BEA Research Reactor Package

**Safety Analysis
Report
Docket 71-9341**

**Revision 10
May 2016**

SUBJECT: 1) BRR Package Amendment Request, Docket No. 71-9341, TAC No. L25031
2) Letter from Norma Garcia-Santos to Philip W. Noss of March 31, 2016, transmitting second NRC request for additional information (RAI)

Figure 1.2-17 – Cross Section View of BRR Package Showing Basket, Loose Plate Box, and Loose Plates

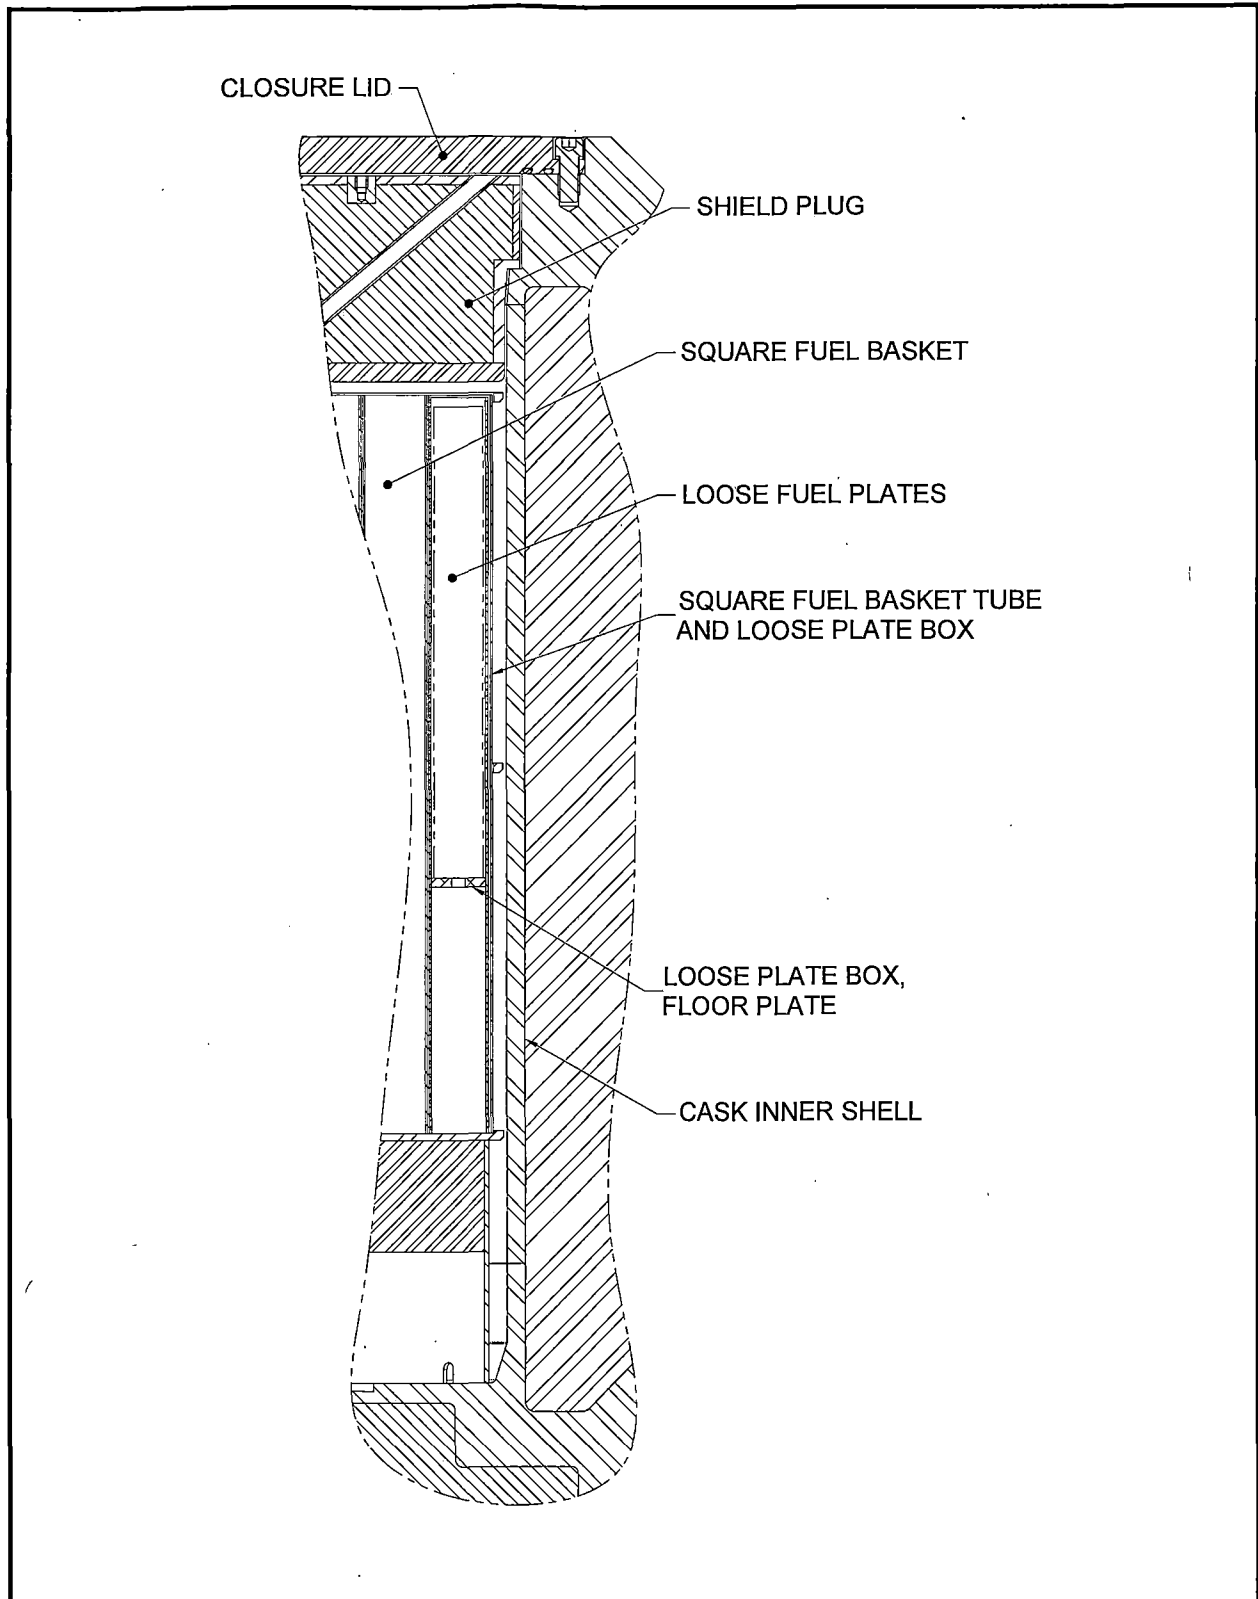
Response: Drawing 1910-01-01-SAR shows that the shield plug forms the top surface of the payload cavity, which defines the upper position limit for each of the baskets, as well as the fuel elements, loose plate box, and the loose plates. The loose plate box is designed to position the loose plates as close as practical to the top surface of the basket, and consequently there is relatively little clearance between the top of the loose fuel plates and the position limiting function of the shield plug. For this reason, the loose plates cannot move a significant distance in an axial direction, and cannot escape the confines of the loose plate box. Thus, no cover to the loose plate box is required. To assist in clarifying this matter, Figure 1.2-17 has been added to Chapter 1. This figure shows a cross sectional view of the cask cavity, the Square fuel basket, loose plate box, and loose plates.

Section or page no. of change	Material changed	Reason for change
1.2.2.5	Added reference to Figure 1.2-17	Update.
1.2.3	Updated discussion of plutonium	To strengthen the discussion of the plutonium source term.
Figure 1.2-17	Added figure	To help clarify the configuration of the loose plate box in the square fuel basket.

A loose plate box is used to transport up to 31 loose plates per box. Loose plates are limited to U-Mass (aluminide), U-Florida, and Purdue fuel plates. A depiction of the Square fuel basket, loose plate box, and loose plates inside a BRR package is shown in Figure 1.2-17.

Figure 6.4-3 – Plate Optimization Study

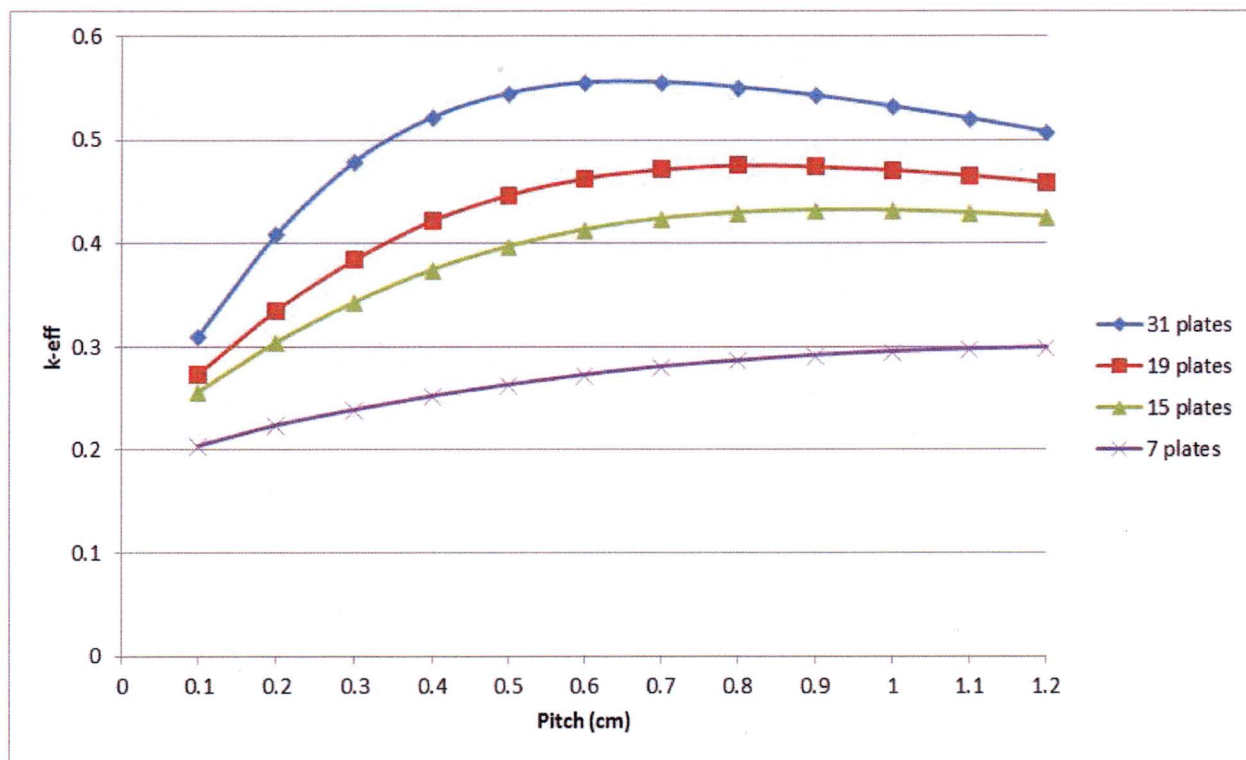
Non-uniform pitches are also considered. Additional non-uniform pitch cases with 25 plates and 19 plates are added in Table 6.4-8 to demonstrate that 31 plates in a non-uniform pitch bounds all other configurations with less plates.

Section or page no. of change	Material changed	Reason for change
	removed.	
Table 6.4-12	U-Florida fuel analysis rerun with more cycles.	RAI Cr-6-3 ₂
Figure 6.4-3	New figure showing moderation curves for different numbers of fuel plates.	RAI Cr-6-2 ₂
Figure 6.4-7	New figure showing geometry corresponding to new loose plate box cases.	RAI Cr-6-2 ₂
Table 6.5-3	Loose plate results updated.	RAI Cr-6-2 ₂ and Cr-6-3 ₂ .
Table 6.6-5	Loose plate results updated.	RAI Cr-6-2 ₂ and Cr-6-3 ₂ .

Four representative plate systems are examined (31 plates, 19 plates, 15 plates, and 7 plates), and the pitch is adjusted between 0.1 and 1.2 cm to determine the optimum moderation for each system, as shown on Figure 6.4-3. Based on Figure 6.4-3, the optimum pitch for each of the systems examined is shown in following table.

Figure 6.4-7 – LPB Loading/Unloading

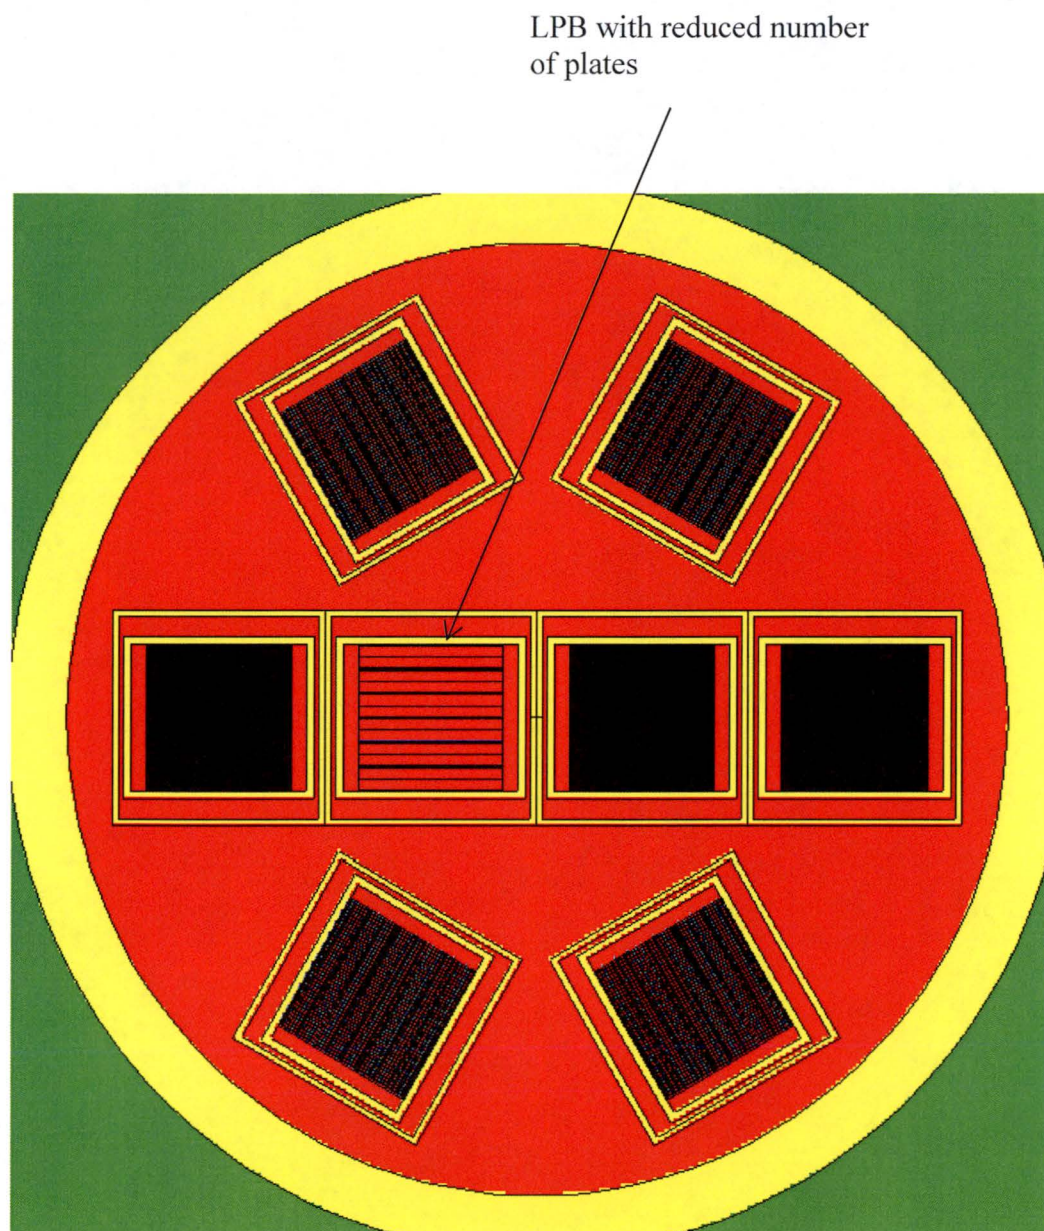
This instruction seems to leave the users to determine if dunnage is necessary. However, the criticality safety analyses credited the dunnage as shown in Figures 6.4.7 to 6.4.11 of the application. This instruction could lead to a potential criticality safety accident as it stands because the instructions seem to indicate that the dunnage is an optional component of the packaging but it is in fact a component important to safety because the criticality safety of the package is dependent on the dunnage. The applicant also needs to revise the Operating Procedures to provide clear instructions for the use of dunnage.

Response: The text of Section 7.1.2.1, *Wet Loading*, and Section 7.1.2.2, *Dry Loading*, has been revised to prevent the confusion between *spacer plates*, which pertain only to U-Florida fuel elements, and *dunnage sheets*, which pertain only to loose plates. The use of spacer plates with U-Florida fuel elements has always been required by the procedure. These spacer plates (not dunnage) are the items shown and credited in Figure 6.4-7 through Figure 6.4-11 of the application. The SAR has been revised to also require the use of dunnage sheets to reduce the gap between the loose plates and the loose plate box to ¼ inches or less. (Note: dunnage sheets are not required if the gap is already equal to ¼ inches or less, without them. Thus, the words "as necessary" are still present, because
